IEEE 802.3 Major PAR form questions

The following are the Major PAR responses for the IEEE P802.3dq draft PAR

Figure 148–1—Relationship of PLCA Reconciliation Sublayer to the ISO/IEC OSI reference model and the IEEE 802.3 Ethernet model

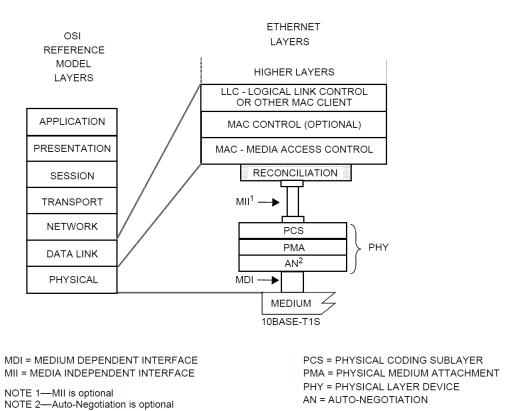
Question for Mr. Law:

Does MII between MAC and PHY over-constrain or cause issues with supporting PLCA?

Response Summary:

The PAR scope should include reference to either updated or new RSs to support the new MII.
